Development Application Representation Letter

DA0321/2017

7 Cartiere Place, Newstead in Tasmania

REPRESENTATION – DA0321/2017 RESIDENTIAL – MULTIPLE DWELLINGS; CONSTRUCTION OF TWO DWELLINGS

FIG.1 SUN STUDY JUNE 22 9AM

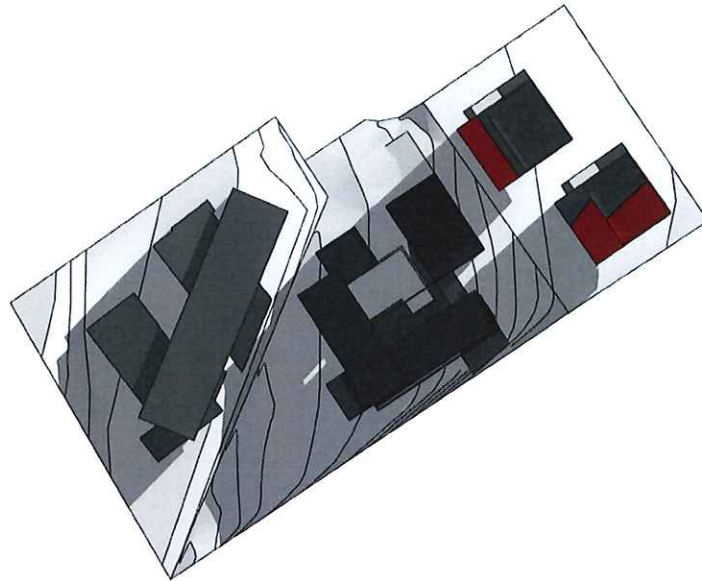
2. We do not feel that sufficient information has been provided in order to determine the level of overshadowing that the units will cause on the adjoining properties on either side and therefore compliance with the performance criteria. Were shadow diagrams provided by the applicant? We have provided diagrams illustrating the level of over shadowing that occur to our property based on the building envelope breaches which are attached to this letter. Whilst we have not generated shadow diagrams for the vacant lot to the east (5 Cartiere Place) we feel that the location of unit 2 will clearly overshadow this property particularly in the afternoon which will severely compromise the location and design of a future dwelling including its private open space which is likely to be overshadowed. Again, have shadow

FIG.2 SUN STUDY JUNE 22 2PM

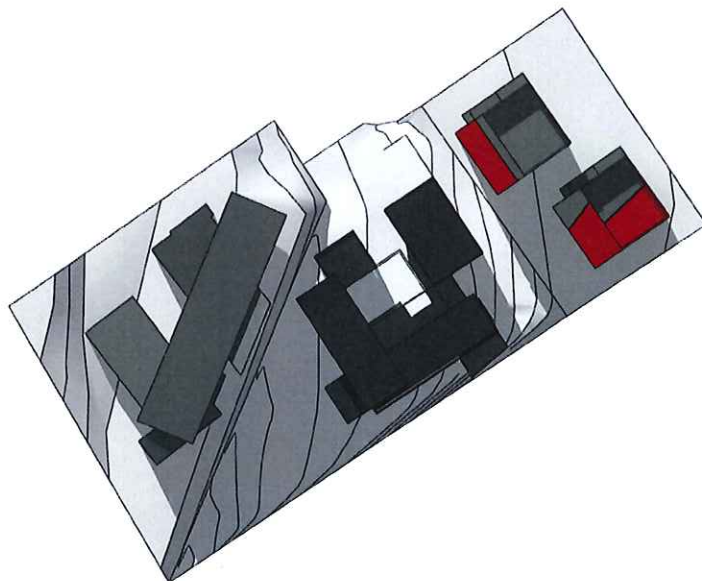
3. We note that Figure 2 – below – indicates the level of overshadowing that will occur to our property from the building that has been constructed to the west. The elevation of this building towers in excess of 7.5m above the ground level of our property and is within 1.5m of the boundary and greater than 9m in length and well outside the building envelope. So we are already impacted by a dwelling that has been approved outside the building envelope on the west side so it is a reasonable request that he is not impacted on by the proposed development as well.

FIG.3 OVER SHADOWING 8AM (PROPOSED)

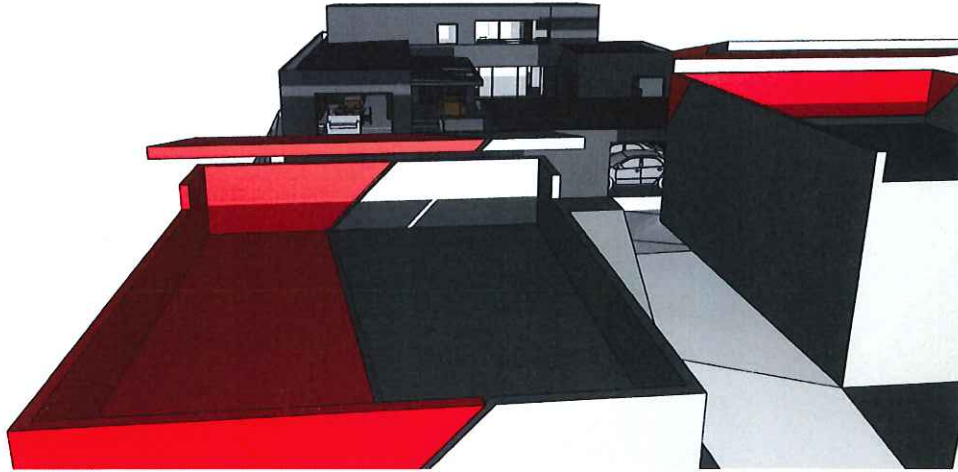
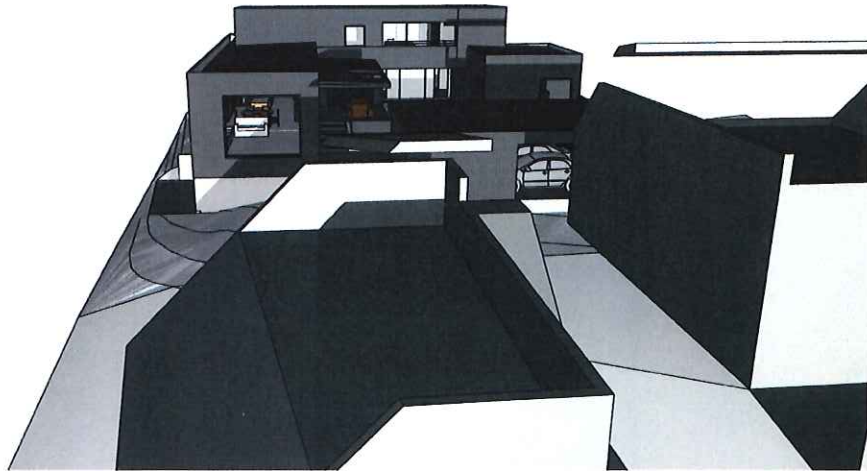
1. The sections of each unit that are outside the prescribed building envelope are substantial and will result in significant overshadowing of the following habitable areas:
 - a. Unit 1 will overshadow our courtyard during autumn and winter morning hours significantly more than a compliant dwelling unit would;
 - b. Unit 2 will overshadow our main living area window which we designed to receive sunlight and view based on a building envelope compliant dwelling being built on the adjoining property.

We do not feel that the level of overshadowing that will be caused by the units is reasonable particularly given that it can be avoided with a more conservative and sensitive design;

FIG.5 KITCHEN VISUAL BULK (PROPOSED)

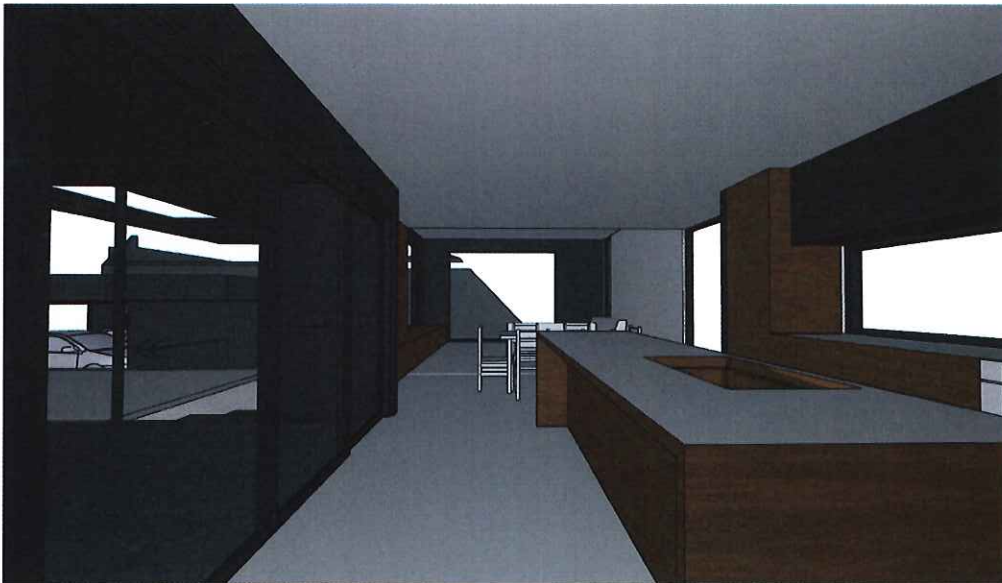
4. The visual impacts caused by the substantial encroachment in terms of scale, bulk and proportions will severely diminish our amenity. The wall of unit 1 will almost be 7-7.5m in height, 9m in length and will be setback 1.5m from our shared boundary. This substantial structure so close to our boundary will clearly dominate and tower over our property. The same can be said about the rear boundary encroachment of unit 2. We have provided images of the impact of the proposed units when viewed from our main living, kitchen and courtyard spaces which compares the proposed units with and without the building envelope breach.

FIG.7 LIVING ROOM VISUAL BULK (PROPOSED)

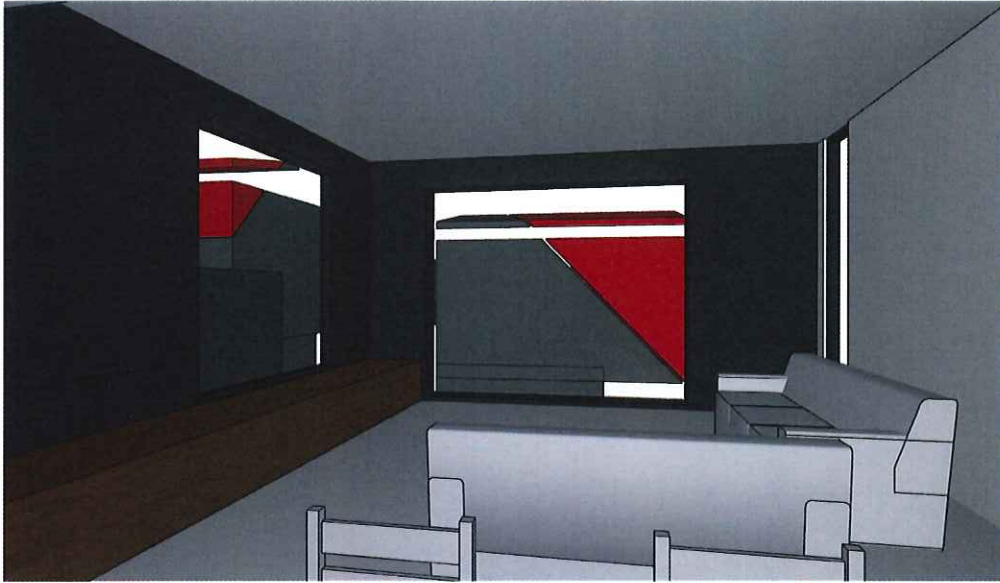
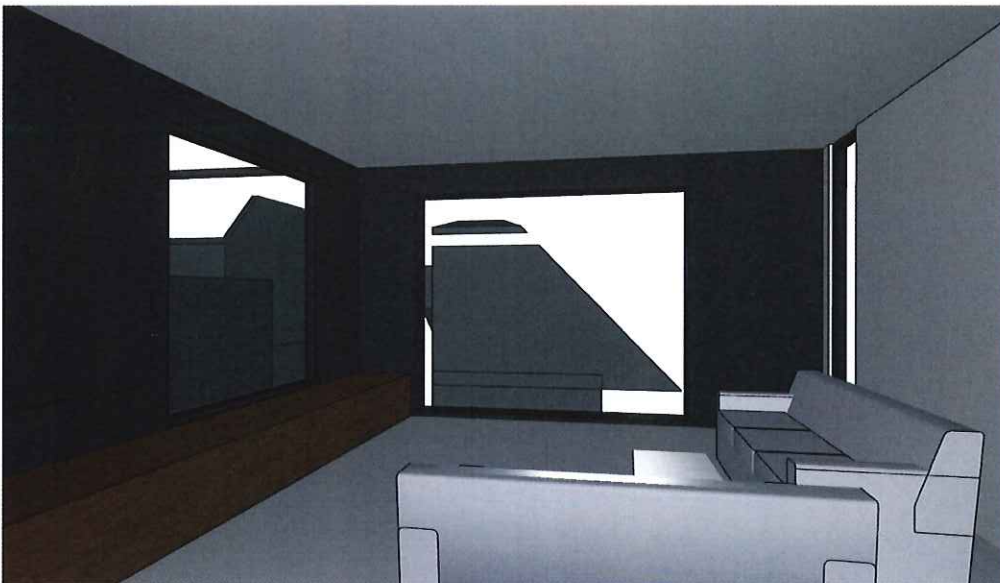
We understand that the protection of a view is outside of the planning scheme where a development complies with the relevant acceptable solutions. We were aware that a house would be built on this property and designed our indoor and outdoor living spaces to avoid as much as possible being an impact upon adjoining development (i.e compliant or close to compliant building envelope development). However, the proposed units will clearly cause a visual impact upon us in terms of scale and bulk. We have prepared some montages of how the units will be seen from our indoor and outdoor living spaces which are attached to this letter;
